Service Bulletin

Subject: Intermittent Unable to Charge from DC Fast Charge

Models: 2014-2016 Spark EV

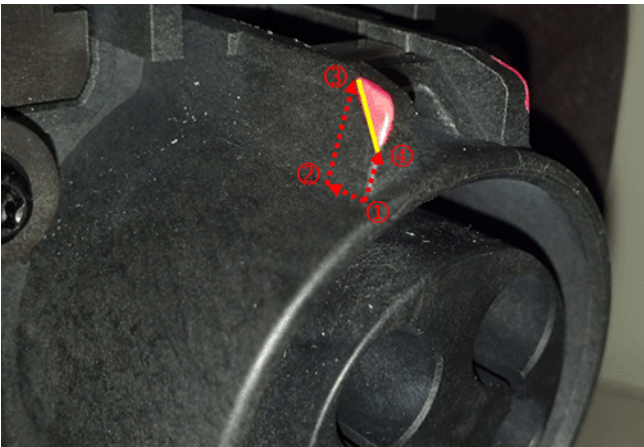
2. Mask off the charge port so that no debris can enter the plug area, leaving exposed upper guides.

Note: Upper receptacle guides are marked in yellow for illustration purposes only.

3. Starting at point "1" as shown above, measure 6 mm to point "2" and 3 mm to point "4." The material above that mark (shown in red above) will be the material removed. Repeat on second receptacle guide.

Important: It is important to follow the dimensions as given above to ensure the interference concern is addressed.

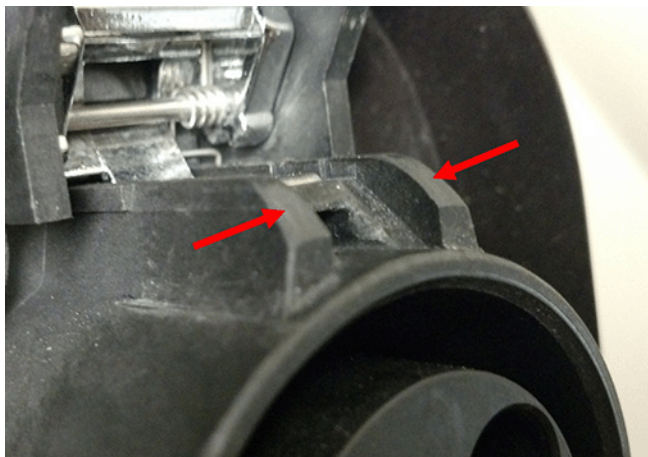
4. Using a file, remove material from both upper guides of receptacle as shown above.

Important: Do not damage the inner seal of the receptacle. Recommend taping the end of file to protect the seal.

5. After filling down the guides, use fine sand paper to remove any burrs or rough edges as shown above. Remove tape and ensure no residue is present.
Important: Do not use solvents that could damage the receptacle when cleaning any residue. Recommend wiping clean with an emery cloth.
6. Using a compressor, clean area of any left over debris.
